REV.
D

AS1895™/10

RATIONALE

FLANGE, MALE, BUTT WELD,
TYPE I STANDARD PROFILE

FIGURE 1 - TYPICAL SECTION

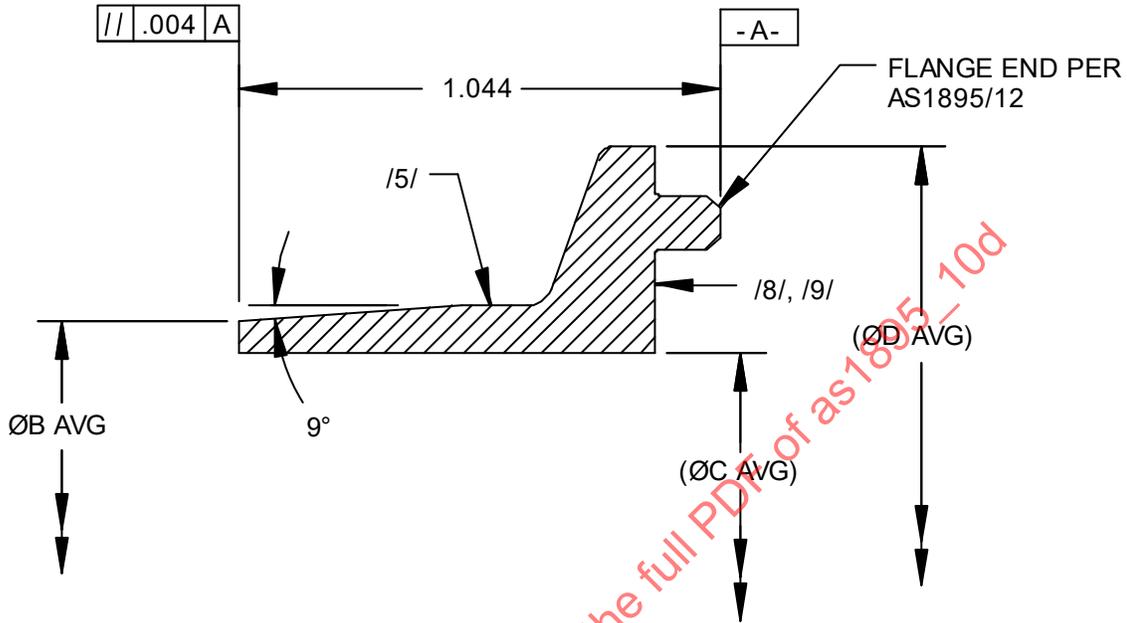
GRAPHICS REDRAWN. CIRCULARITY REQUIREMENT REMOVED FROM ØB. PERPENDICULARITY REQUIREMENT REMOVED FROM REFERENCE ØC. TABLE 1 REDRAWN TO ADD "REF" TO DIM C AND D. NOTE 3 REVISED TO STATE CURRENT QML NOTE. GENERAL UPDATING OF SPECIFICATIONS BEING SPECIFIED HEREIN. CHANGE BAR NOTE REVISED. NOTE 17 ADDED.
